STATE OF NEW HAMPSHIRE
PUBLIC UTILITIES COMMISSION

DG 06-105

In the Matter of:
KeySpan Energy Delivery New England
2006 Integrated Resource Plan

Surrebuttal Testimony

14
15
16
17
18
19
20 Figure 1
21

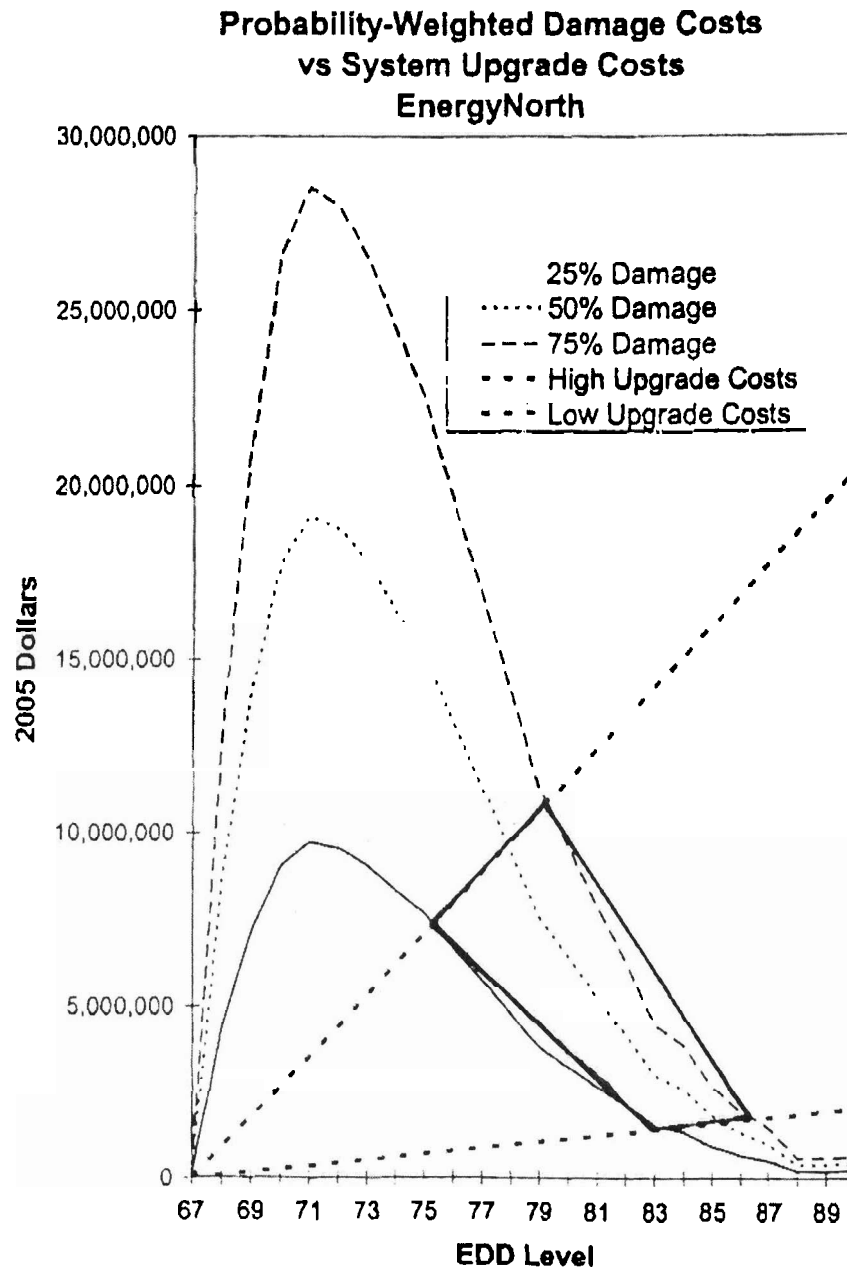
14
15 Q. WHAT ARE THE IMPLICATIONS OF THIS COST UNDERSTATEMENT?
16 A. To understand the implications, we must first understand the Company's
17 analysis. Figure 1 is a copy of Chart III-E-7 from the Company's 2006 IRP,
18 which shows probability-weighted damage costs and system upgrade costs
19 plotted as a function of EDD. Because of the uncertainty regarding the
20 percentage of residential customers that might experience heating system
21 freeze-up and consequent need for remodeling, the probability-weighted
22 damage costs were presented by the Company at three different levels. To

1 clarify the Company's analysis, I have drawn on the chart the geometric shape
2 that is formed by the intersection of the damage cost curves and the system
3 upgrade cost curves. According to the Company, the center of this geometric
4 shape represents the design day standard and is located at 80.2 EDD.

5
6 Using Figure 1, it seems clear that if the incremental supply costs in the
7 financial analysis are understated the gradient of each cost curve will be too
8 low. Correcting for this error will result in new intersection points at lower
9 EDD levels and a new geometric shape that is shifted to the left of the shape
10 shown in the chart. This means that the center of this new shape will be located
11 below 80.2 EDD. In conclusion, the Company's proposed design day standard
12 of 80 EDD cannot be supported by the updated cost estimates provided in DG
13 07-101.

1 reliability but also the commodity costs associated with the use of the
2 incremental capacity. At the low end of the cost range, this would mean adding
the loss adjusted cost of propane to the fixed costs of the propane facilities. At
the high end of the cost range, this means adding the loss adjusted delivered cost
of natural gas, off-set by any commodity cost savings associated with the
inclusion of addition pipeline capacity in the resource portfolio. The fact that
neither of these costs was integrated into the financial analysis provides further
evidence that the cost curve gradients in the above chart are too low and that the
proposed design day standard of 80 EDD is too high.
